RE: BEHS PSC - BG 25-145 - Change Order 12 - Concrete Control Joint Installation

## Change Order

**PROJECT:** *(Name and address)*  
 BCPS Phase III - Bid Package No. 1 -  
 Bullitt EAST Physical Science Center

# Change Order Request 12 - PCO #29 - BEHS Control Joints 2nd Level

BEHS Control Joints 2nd Level

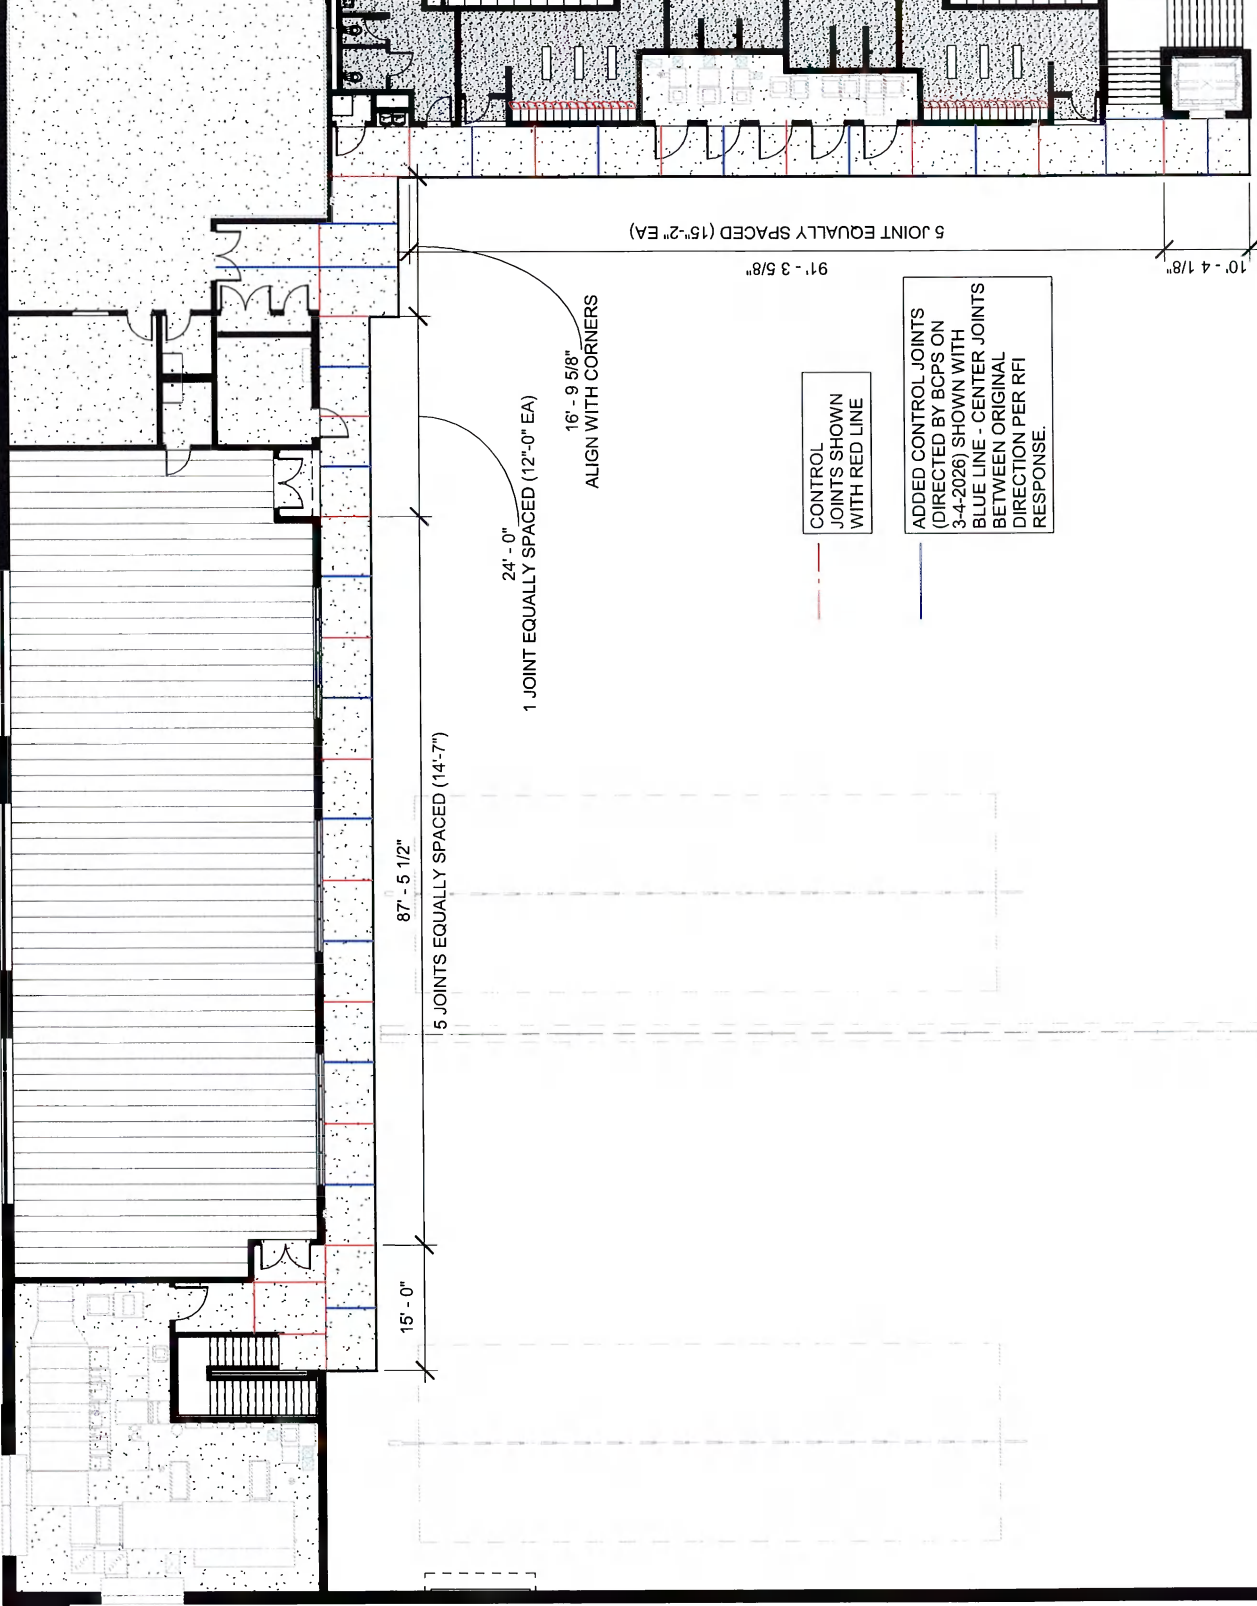
It is recommended that additional control joints be added at the elevated walkway concrete slab to mitigate superficial cracking. Joints were added by the architect, and then additional joints were requested by Facilities. These joints can be added via a saw-cut method after the slab poured.

CONTROL JOINTS SHOWN WITH RED LINE

ADDED CONTROL JOINTS (DIRECTED BY BCPS ON 3-4-2026) SHOWN WITH BLUE LINE - CENTER JOINTS BETWEEN ORIGINAL DIRECTION PER RFI RESPONSE.

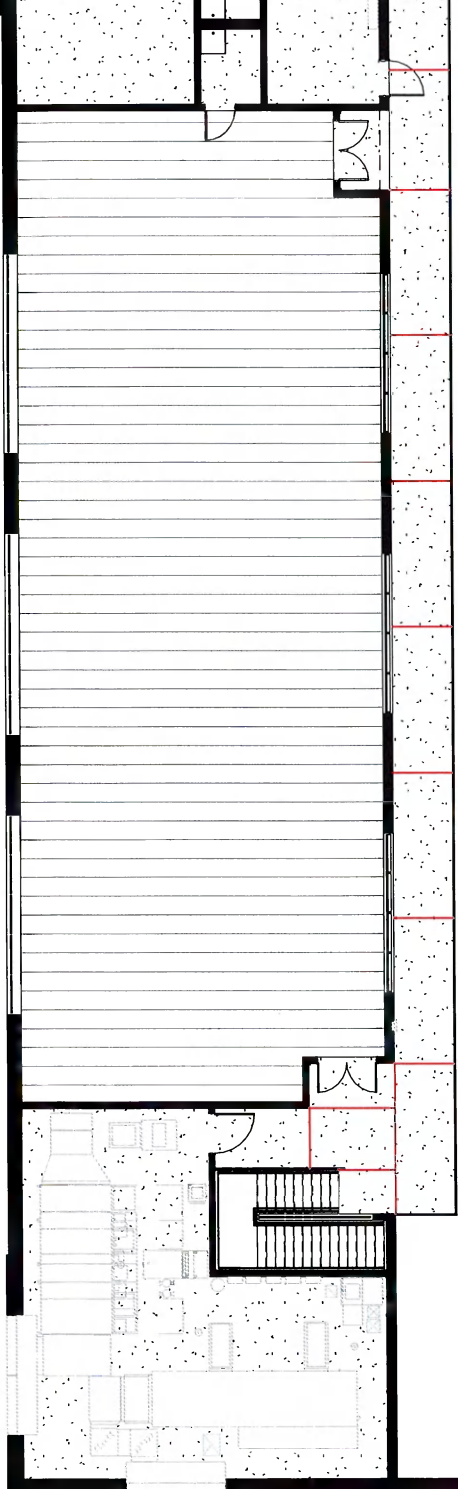
Hi Brent... can you please send pricing for the joint sealants at the added controls joints shown on each building attached? I need the costs separated.

CONTROL  
JOINTS SHOWN  
WITH RED LINE

To confirm here, control joints shown in the wrestling room per my response to RFI #26 can be omitted. Updated plans of both facilities are attached for your use.
